UNITED STATES PATENT AND TRADEMARK OFFICE

10/529,135

Office Action Summary

DETAILED ACTION

FIG. 1

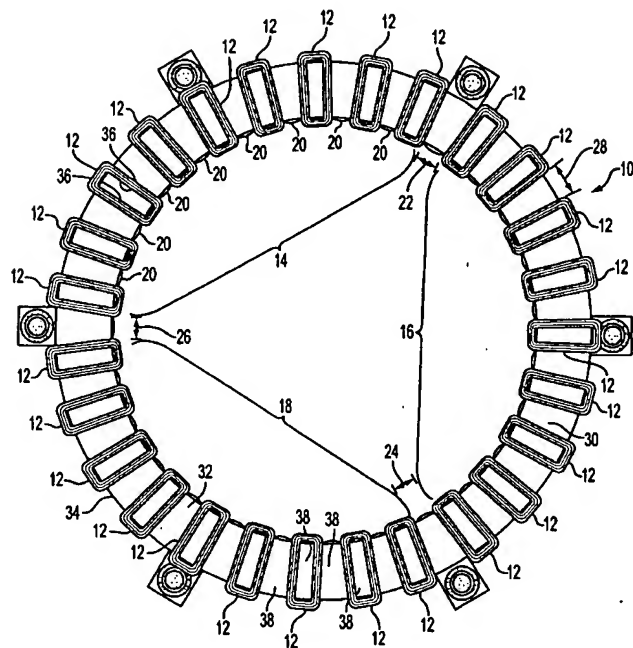
- Housing (71A, 71B, 71C, Fig. 7) supporting a rotor (72, Fig. 7) through an assembly of a plurality of stators (10', Fig. 5 and Fig. 7).
- Stator (10', Fig. 5 and Fig. 7) having a ring type laminated flat structured stator core (30, Fig. 5; col. 10, lines 29-32).
- A plurality of teeth cores (38, Fig. 1 and Fig. 5) having winding coil (12, Fig. 1), which are slotted constantly around the inner or outer circumference of stator (10', Fig. 5 and Fig. 7).
- Rotor frame (72, Fig. 7) with a plurality of magnets (74, Fig. 7; col. 13, lines 34-36) fixed on a rotor shaft (104, Fig. 7) through a bearing (76, Fig. 7).

- Laminated flat core structure of teeth core (30, Fig. 5; col. 10, lines 18-21).
- Stator core (30, Fig. 5) with multi slots (36, Fig. 5; col. 11, lines 16-18) with a constant distance around the circumference of stator (10', Fig. 5 and Fig. 7).
- Teeth core (38, Fig. 1 and Fig. 5) having a number of teeth (38, Fig. 5) and constant thickness.

Sheet 3 of 21

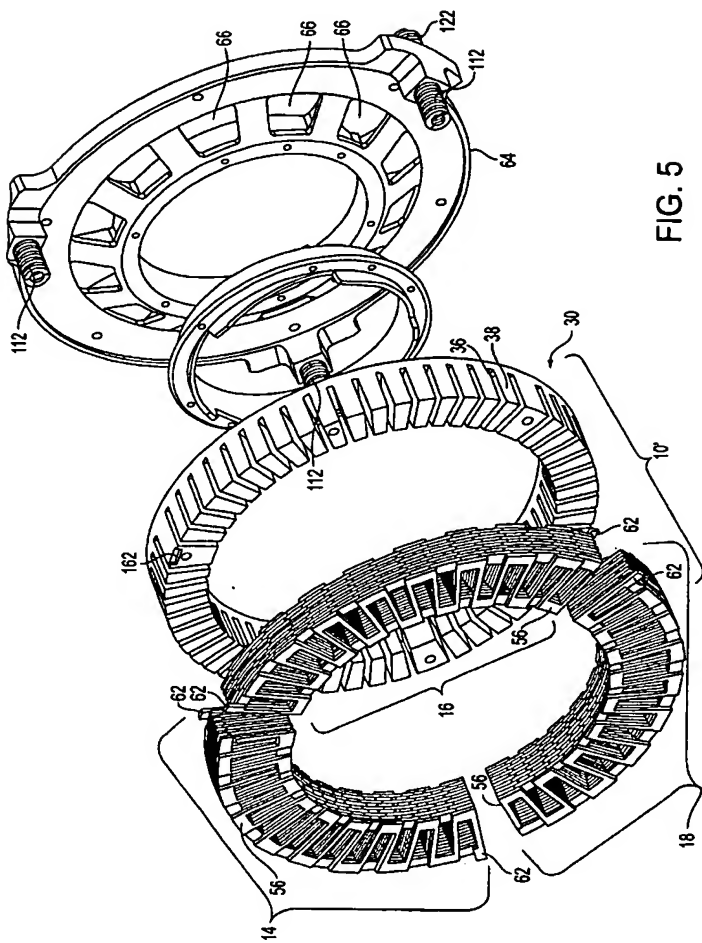
In re claim 6, Jermakian et al. '203 discloses a laminated flat core structure of teeth core (30, Fig. 5; col. 10, lines 18-21), a stator core (30, Fig. 5) with multi slots (36, Fig. 5; col. 11, lines 16-18) with a constant distance around the circumference of stator (10', Fig. 5 and Fig. 7).

Sheet 5 of 21

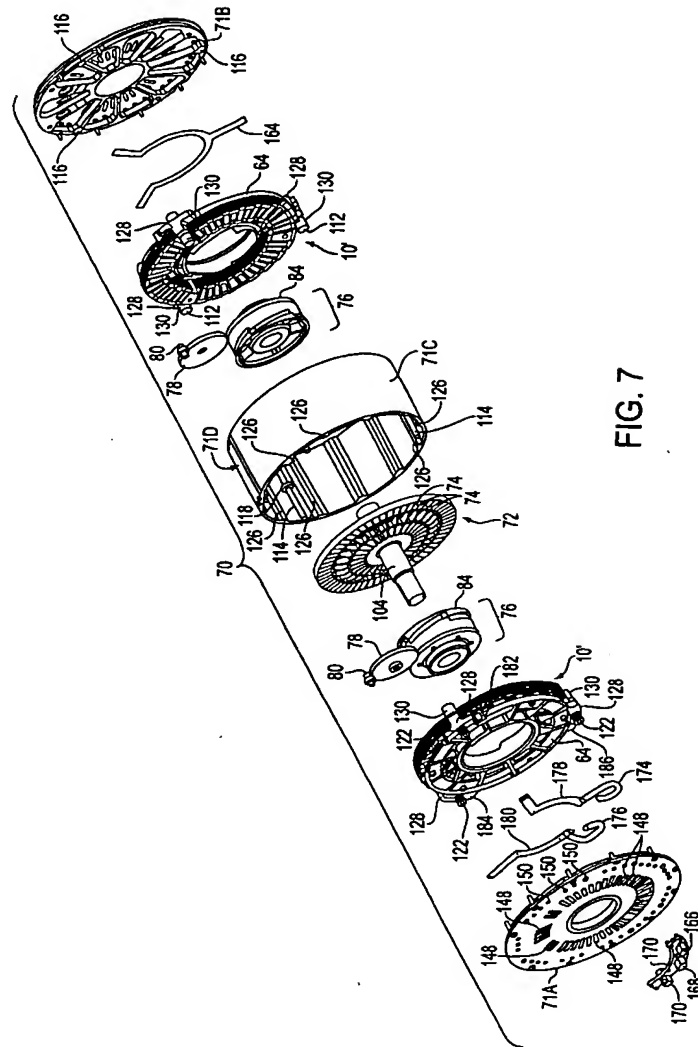
- Magnets (74, Fig. 7) have even number of magnetic poles (col. 9, lines 562-64; col. 11, lines 16-18).

- Said plurality of magnets (74, Fig. 7) installed along the axial direction of the rotor (72, Fig. 7) facing against said plurality of stators (10', Fig. 5 and Fig. 7) in housing.

FIG. 1
INVENTOR
A. J. C. BAKHUIZEN
BY *[Signature]*
AGENT

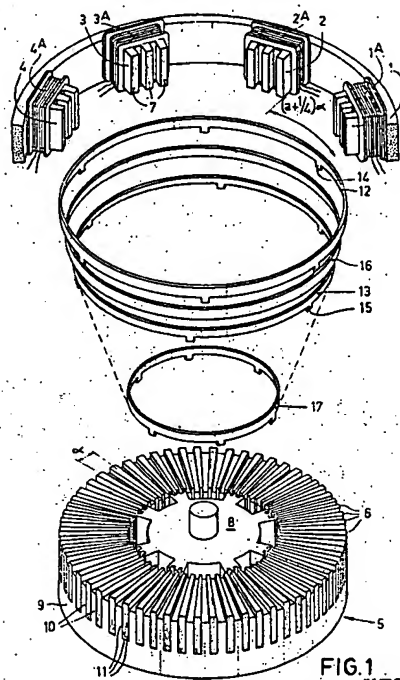
- An induction motor (5, Fig. 1) along the axial and radial (5, Fig. 1) direction of the rotor (5, Fig. 2) on a flat circular rotor frame (9, Fig. 2).
- Induction motor (5, Fig. 1) consisting of teeth core (6, Fig. 1) with a constant thickness facing against stator teeth core (7, Fig. 1) and insulated by short circuit rings (12-17, Fig. 1; col. 3, lines 45-48).
- A laminated rotor core (9, Fig. 2; col. 3, lines 44-45) with a short circuit ring (12-17, Fig. 1) insulated (col. 3, lines 57-61) between teeth core (6, Fig. 1).
- Rotor core (9, Fig. 1) consisting of multi slots (11, Fig. 1) with a constant distance around the inner circumference of said stator core as seen in Figure 1.

The advantage of Bakhuizen '225 short circuit rings (12-17, Fig. 1) and induction motor (5, Fig. 1) consisting of a plurality of rotor teeth (6, Fig. 1) is achieving high speed coarse positioning (col. 2, lines 1-3) and uniform torque (col. 1, lines 63-64) in the motor.

In re claim 7, Figure 1 of Bakhuizen '225 discloses a laminated rotor core (9) with a short circuit ring (12), in Figures 1 and 2, insulated (col. 3, lines 57-61) between teeth core (6) seen in Figure 1. Multi slots (11) in rotor core (9) with a constant distance around the inner circumference of said stator core as seen in Figure 1.

In re claims 8-10, Bazkhuizen '225 discloses an induction motor (5) in figure 1 along the axial direction of the rotor, as well as a plurality of stators (1-4) in the housing facing against the induction motor (5) in Figure 5.
